**Revised  
Corrective Action Plan  
Proposed Aspire High School Site  
1009 66th Avenue, Oakland, California  
(Fuel Leak Case No. RO0000411)**

**July 17, 2009  
003-09155-02**

Subject: Revised Corrective Action Plan, Proposed Aspire High School Site, 1009 66th Avenue, Oakland, California (Fuel Leak Case No. RO0000411)

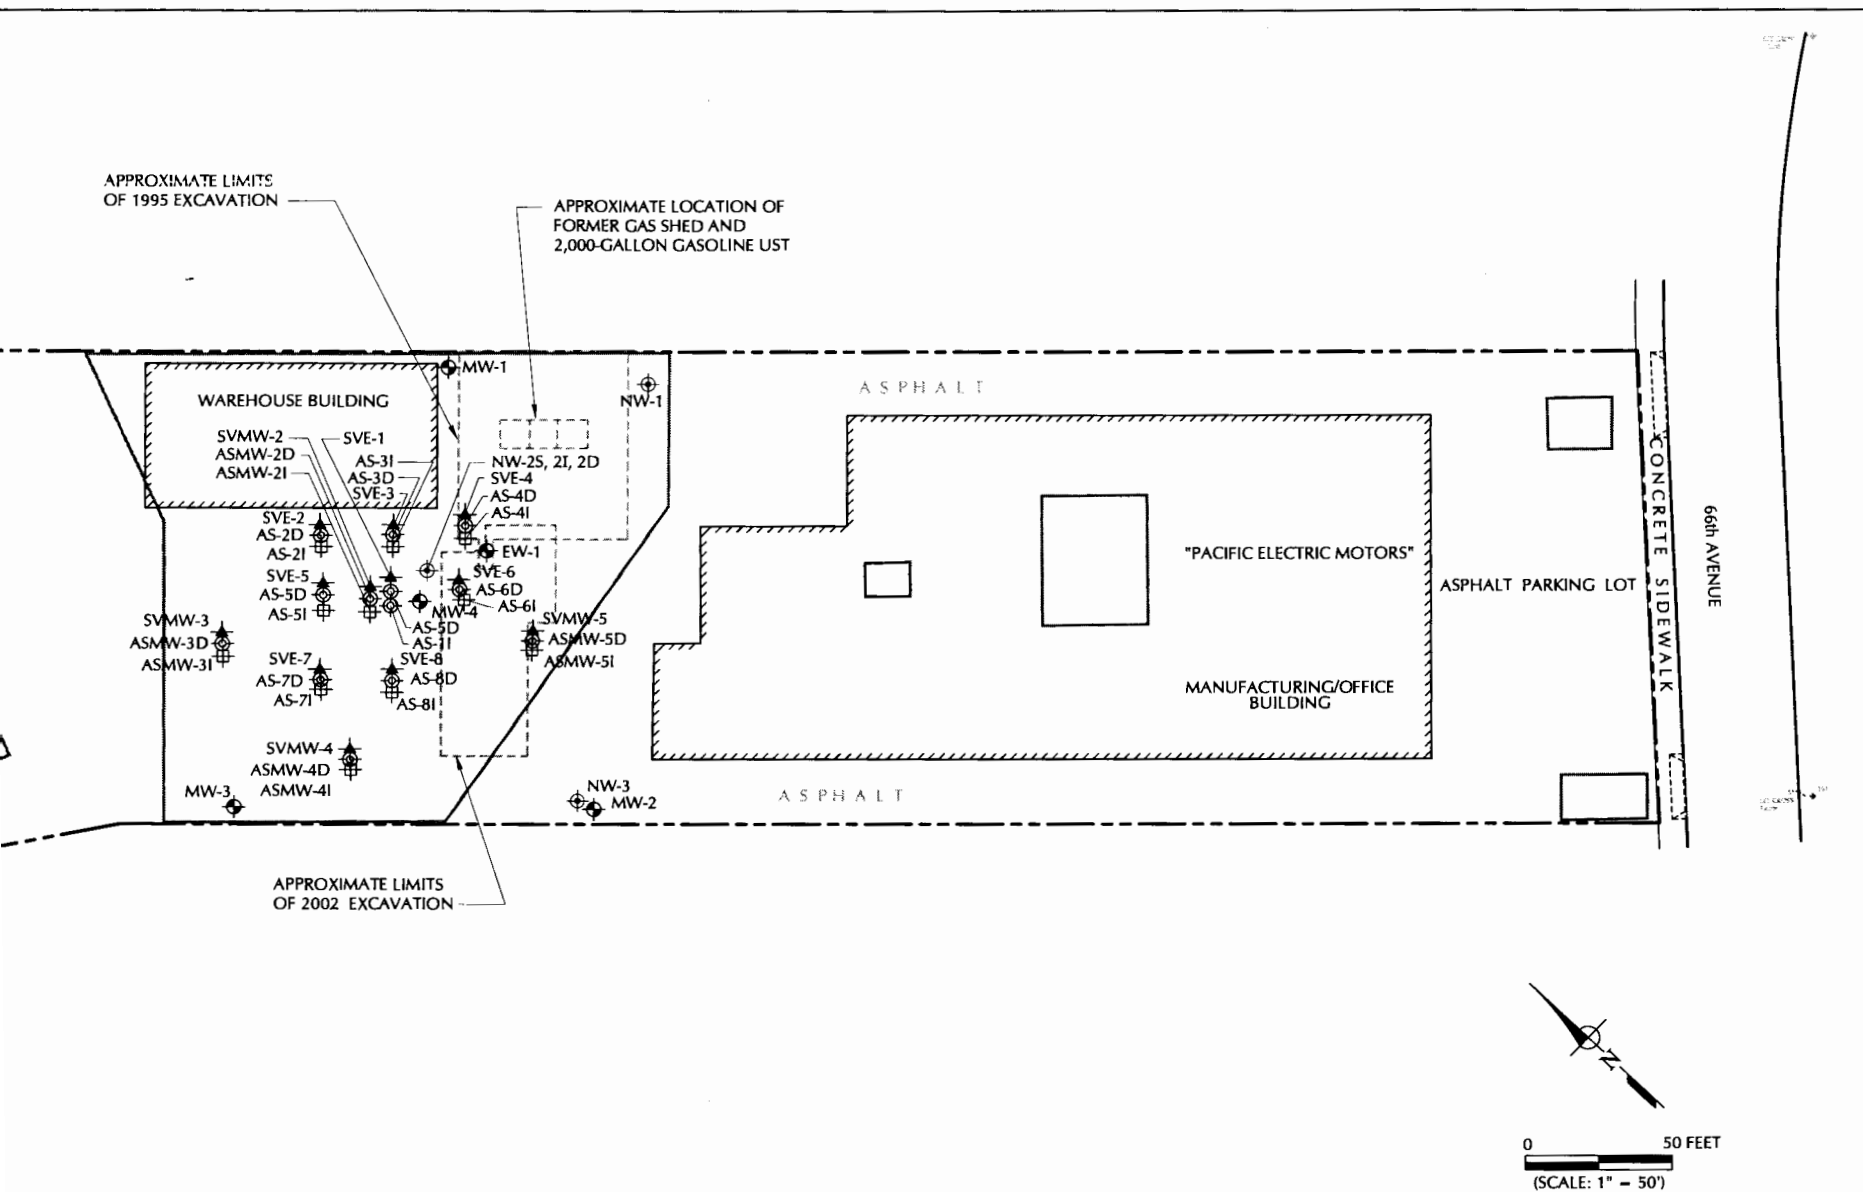
4. *Revised Site Figures* – Revised figures are included in the revised CAP. Specifically, a map illustrating the proposed area of excavation (Figure 10) has been included in the CAP. In addition, the analytical results for groundwater samples recently collected at the Site and the estimated radius of influence of the groundwater remediation system are provided as Figure 9.

As shown on Figure 9, affected groundwater in both the intermediate and deep water-bearing zones is generally localized to an area immediately west of the Warehouse near the former UST. Residual groundwater impacts are also present immediately east and west of the excavation footprint(s).

Figure 9 shows that the highest concentration of total petroleum hydrocarbons as gasoline (TPHg); benzene, toluene, ethylbenzene, and total xylenes (BTEX); and methyl tertiary-butyl ether (MTBE) were detected in groundwater samples collected from wells MW-4, ASMW-2I, AS-5I, AS-6I, and ASMW-5I. The estimated extent of affected groundwater is delineated by wells located downgradient from the former UST location (MW-2, MW-3, NW-1, and NW-3). As indicated, the highest concentrations of TPHg and related compounds have been detected in groundwater samples collected from wells completed in the intermediate zone (Figure 9).
